<b>Well Name:</b> LOTOS 10 FEDERAL	<b>Well Location:</b> T24S / R31E / SEC 10 / NWNE /	<b>County or Parish/State:</b> EDDY / NM
<b>Well Number:</b> 6	<b>Type of Well:</b> OIL WELL	<b>Allottee or Tribe Name:</b>
<b>Lease Number:</b> NMNM29234	<b>Unit or CA Name:</b>	<b>Unit or CA Number:</b>
<b>US Well Number:</b> 3001534944	<b>Well Status:</b> Producing Oil Well	<b>Operator:</b> CHEVRON USA INCORPORATED

**Sundry ID:** 2722212

**Type of Action:** Plug and Abandonment

**Permanent Abandonment of Federal Wells  
Conditions of Approval (LPC Habitat)**

## PROPOSED WELLBORE DIAGRAM

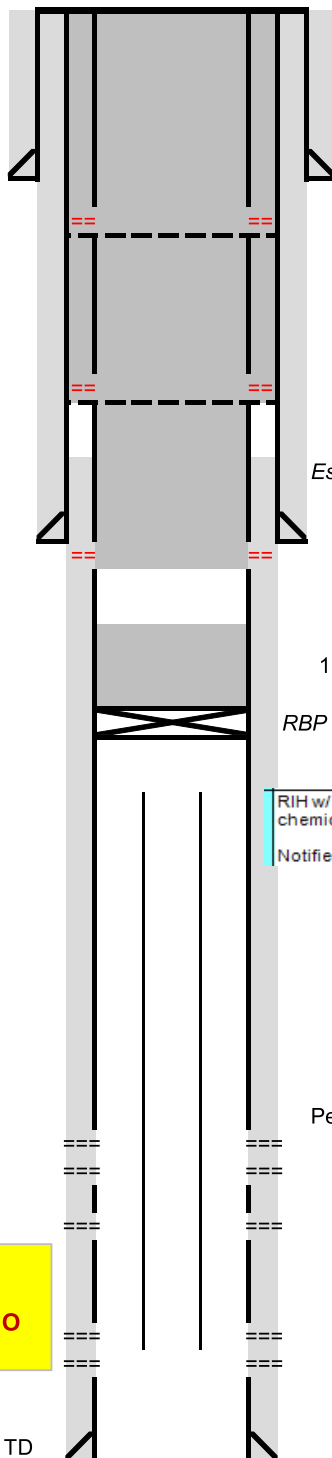
Approval Subject to  
 General Requirements and  
 Special Stipulations  
 Attached

Plug Type	Top	Bottom	Length	Tag	Sacks	Cement Class	Notes
Surface Plug	0.00	100.00	100.00	Tag/Verify			
Shoe Plug	709.33	817.00	107.67	Tag/Verify			
Top of Salt @ 850	791.50	900.00	108.50	Tag/Verify			
				If solid base no need to Tag (CIBP present and/or Mechanical Integrity Test), If Perf & Sqz then Tag, Leak Test all CIBP if no Open Perforations			
Fresh Water @ 868	809.32	918.00	108.68		205.00	C	Perf and squeeze from 876' to surface.
Base of Salt @ 2880	2801.20	2930.00	128.80	Tag/Verify	736.00	C	Perf and squeeze from 4030' to 876'. WOC and Tag.
Shoe Plug	4286.20	4430.00	143.80	Tag/Verify			
				If solid base no need to Tag (CIBP present and/or Mechanical Integrity Test), If Perf & Sqz then Tag, Leak Test all CIBP if no Open Perforations			
Delaware @ 4400	4306.00	4450.00	144.00		40.00	C	Perforate and squeeze at 4450' to 4286'. WOC and Tag.

If solid base no need to Tag (CIBP present and/or Mechanic al Integrity Test), If Perf & Sqz then Tag, Leak Test all CIBP if no Open Perforatio ns			
<b>CIBP Plug</b>	5183.00	5218.00	35.00		25.00	C	Tag RBP at 5218'. Spot 25 sxs on top. Leak Test CIBP.
<b>Perforations Plug (If No CIBP)</b>	6244.00	8248.00	2004.00	Tag/Verify			
<b>Bonesprings @ 8198</b>	8066.02	8248.00	181.98	base no			
<b>Shoe Plug</b>	8216.50	8400.00	183.50	Tag/Verify
